Project Name: Three Waters Wind Farm, LLC Site Permit Application; Minnesota Public Utilities Commission DOCKET NO. IP-7002/WS-19-576

Comments for:
Preliminary Draft Site Permit and Environmental Report Scoping
Three Waters Wind Farm
Docket Nos. CN-19-154 and WS-19-576

How Loud Is A Wind Turbine?

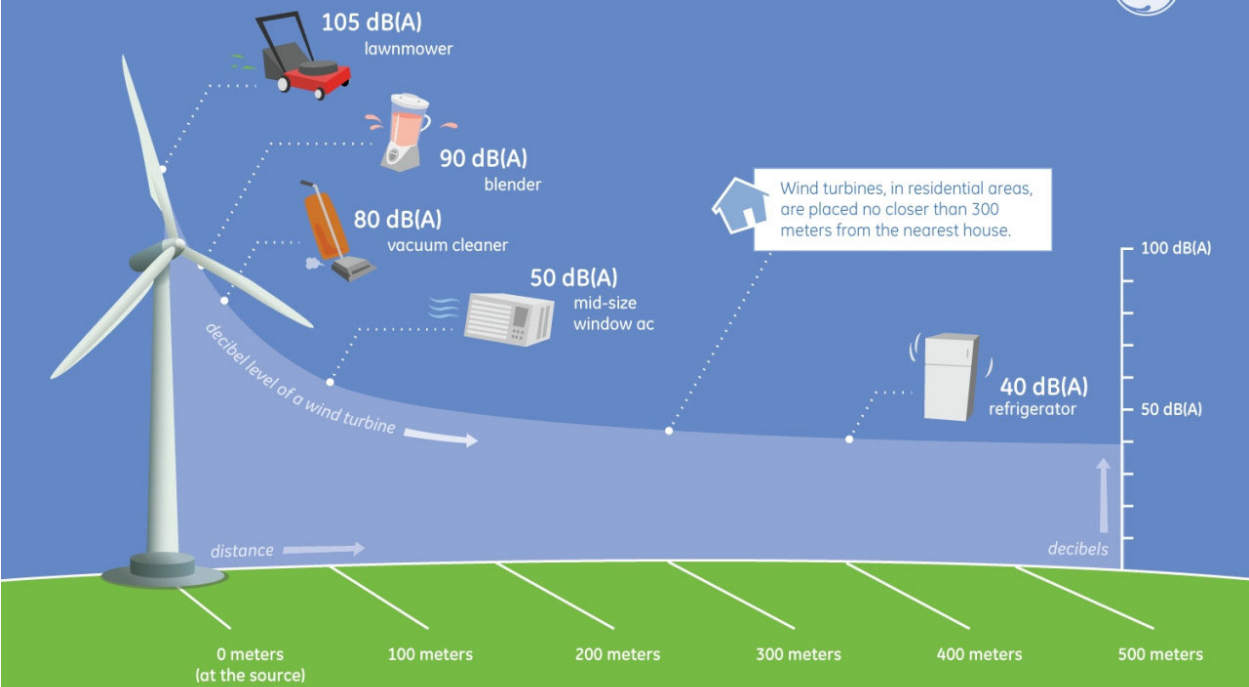
Take a look at GE's "How Loud is a Wind Turbine" slide. Supposedly the turbine makes 105 decibels of noise, comparable to a lawnmower. At 100 meters the sound level supposedly drops down to 50 decibels, the same as a window air conditioner. At 300 meters a popup shows that wind turbines are placed no closer than this to the nearest house. If this slide from GE was honest and true, why wouldn't industrial wind complex developers place the wind turbines a little over 100 meters (328 feet) away from the nearest house to stay within the too high Minnesota state mandated 50 decibel threshold. Where is the science and what is the truth? And anyone who has been by a wind turbine when they are under load and thumping away knows they are a heck of a lot louder than a lawnmower.
